SUBJECT: SUPPLEMENT IN RESPONSE TO DATA ADEQUACY COMMENTS ON THE APPLICATION FOR CERTIFICATION FOR THE EASTSHORE ENERGY CENTER (06-AFC-6)

Eastshore Energy Center
Data Adequacy Supplement
(06-AFC-06)

Eastshore Energy, LLC, a wholly-owned subsidiary of Tierra Energy (Applicant) submitted an Application for Certification (AFC) for the Eastshore Energy Center (Eastshore) to the California Energy Commission (CEC) for a 115 megawatt (MW) natural-gas fired simple-cycle power plant on September 15, 2006. These responses are submitted based on the technical disciplines identified by the CEC and are in response to those items identified in the Data Adequacy Recommendation provided by the CEC Staff on October 19, 2006.

916-C-102, Rev A

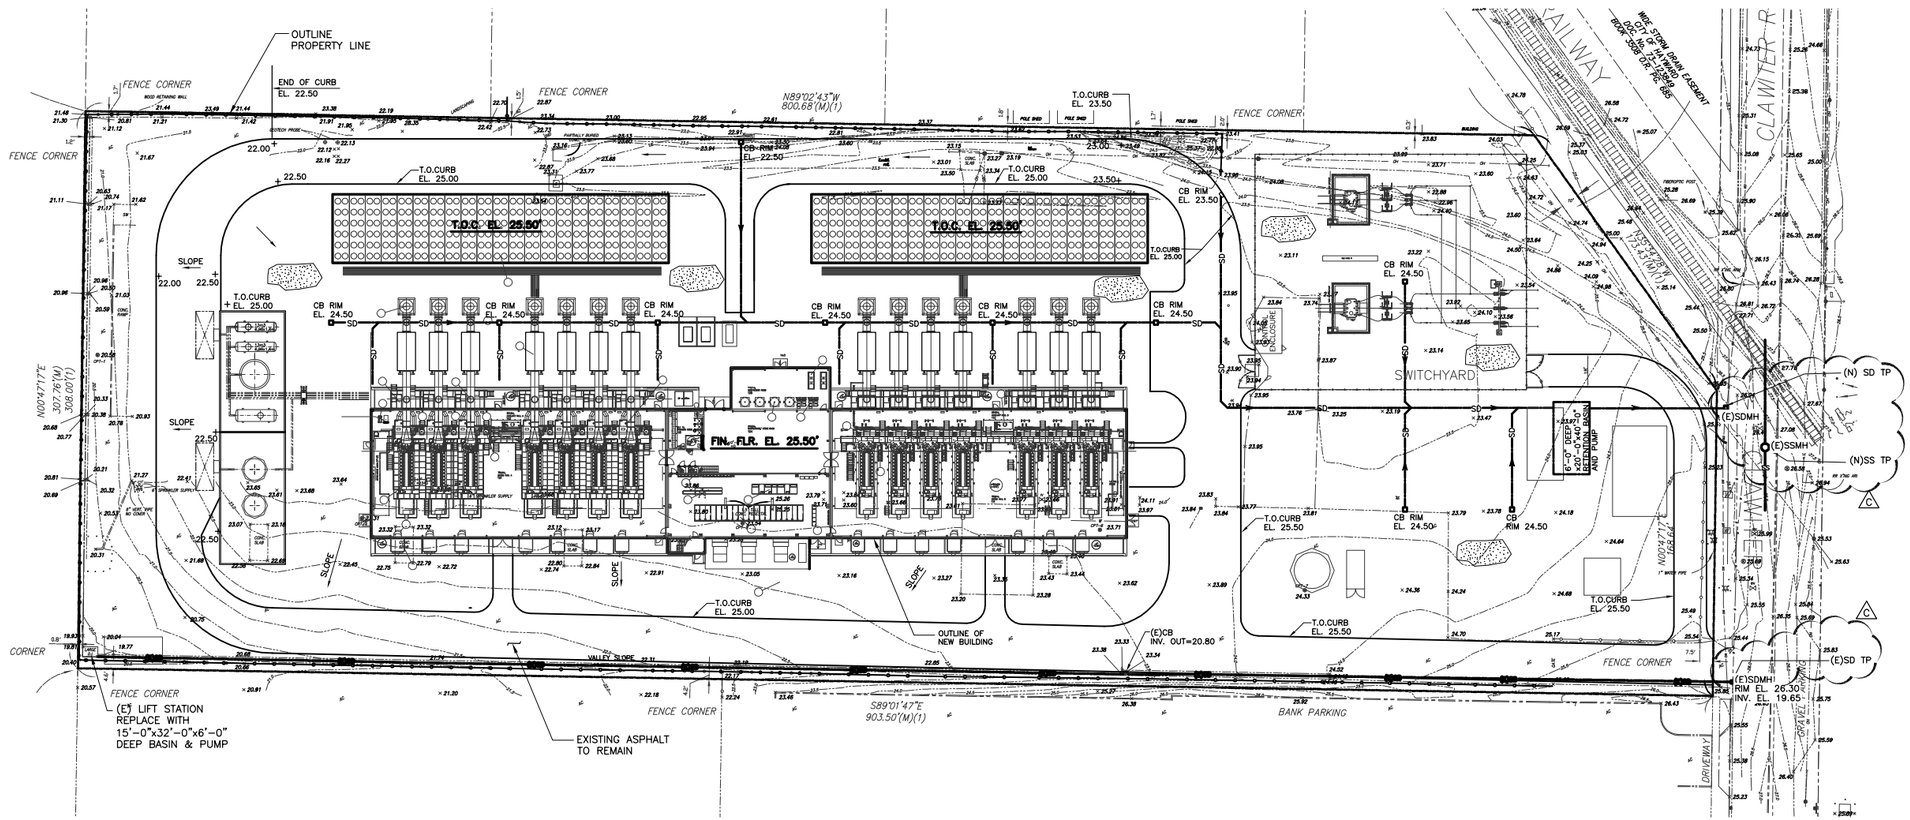
Data Adequacy Deficiency – Provide the design criteria and location of all pre-and post-construction drainage facilities for the site and laydown area. Figure 1.2-3 shows two catch basins without interconnection or discharge points. Please provide all drainage facilities and interconnections/discharge points.

Data Adequacy Response – The attached preliminary drawing 916-C-102, Rev A shows expected pre- and post -construction drainage for the portion of the laydown area Eastshore Energy, LLC will be using for the project. Only the indicated northern portion will be used; the southern portion will be retained for use by Berkeley Farms. Note that Eastshore Energy, LLC does not anticipate performing any grading on this property. However, Eastshore Energy, LLC will lay a base of about 2 inches of crushed rock on the northern portion of the parcel to improve its durability during project use; minimize the collection of dirt on tires; and minimize silt and contaminants runoff. Eastshore Energy, LLC will also employ best practices in order both to prevent collection of contaminants in the indicated catch basin, and to comply with City of Hayward quantity and quality requirements for storm water discharges.
